Access Compliance Report

Public Rights-of-Way

(Curb Ramps)

Intersection ID: 16160	Main Street: MARSH_RD	Cross Street: WRISTON_PL	Location: SE
ADA ID: F73A45B7CC92	Ramp Type: PerpDiag	Initial Pass/Fail: Fail	Overall Compliance: No
Severity Score: 21.25			
Codes/Mitigation Info/Possible Solution		Field Measurements/Component Compliance

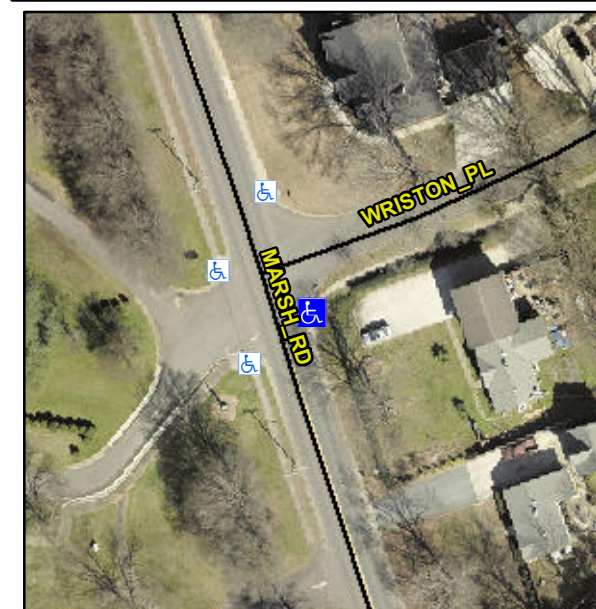
Compliance	Description	Data	Compliance	Description	Data
N/A	Ramp Length (in)	70.0	No	Ramp Slope (%)	8.4
No	Ramp Width (in)	47.0	Yes	Ramp XSlope (%)	1.5
N/A	Flare Type LT	N/A	N/A	Flare Type RT	N/A
N/A	Flare Slope LT (%)	N/A	N/A	Flare Slope RT (%)	N/A
N/A	Flare Traversable LT?	N/A	N/A	Flare Traversable RT?	N/A
N/A	Landing Length (in)	N/A	N/A	DWS Provided?	N/A
N/A	Landing Width (in)	N/A	N/A	DWS Contrast?	N/A
N/A	Landing Slope (%)	N/A	N/A	DWS Length (in)	N/A
N/A	Landing X Slope (%)	N/A	N/A	DWS Full Width?	N/A
N/A	Landing Curb? (Y/N)	N/A	N/A	DWS Offset (in)	N/A
N/A	Shared Landing?	N/A			
N/A	Gutter Ponding?	N/A	N/A	Gutter Slope (%)	N/A
N/A	Gutter Lip Ht (in)	N/A	N/A	Gutter X Slope (%)	N/A
N/A	Painted X Walk1?	No	N/A	Painted X Walk2?	No
	X Walk 1 Direction	To N		X Walk 2 Direction	To SW
N/A	X Walk 1 Width (in)	N/A	N/A	X Walk 2 Width (in)	N/A
	X Walk 1 Slope (%)	2.6		X Walk 2 Slope (%)	2.7
	X Walk 1 X Slope (%)	2.4		X Walk 2 X Slope (%)	2.0

N/A	Ramp inside XWalk1?	N/A	N/A	Ramp inside XWalk2?	N/A
	Road Slope (%)	0.3	N/A	Clear Space?	N/A
	Road X Slope (%)	4.4	N/A	Clear Space to XWalk (in)	N/A
N/A	Any Obstructions?	N/A	N/A	Storm Grate/Utility Hazard?	N/A
	Obstruction Type			Storm Grate/Utility Type	
		N/A			N/A
			Yes	Surface Condition? (G/P)	Good

Remove & Replace Curb Ramp With Two New Directional Ramps or Equivalent.
